DIABLO CANYON EMERGENCY PLAN
IMPLEMENTING PROCEDURES

DIABLO CANYON POWER PLANT PROCEDURE ON-THE-SPOT CHANGE

Type of Change: ☒ PERMANENT (green) ☐ TEMPORARY (yellow); Expiration Date _____

Re: Docket No. 50-275, OL-DPR-76
Docket No. 50-323
Diablo Canyon Units 1 and 2
Emergency Plan Implementing Procedures Updates

Floor Plan of the Technical Support Center

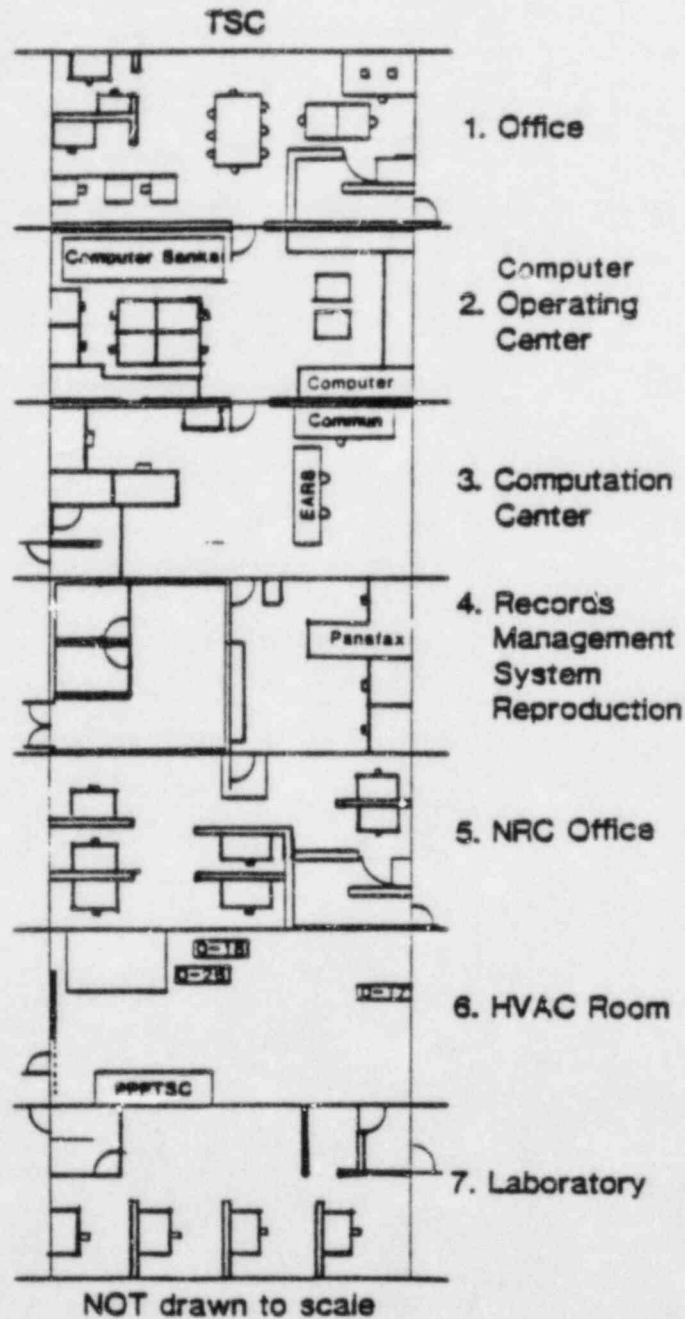
Figure 1 "Floor Plan of the Technical Support Center"
DATED 11/3/83 Replaces Figure 1 dated 9/16/83

UPDATE of The TSC Floor Plan
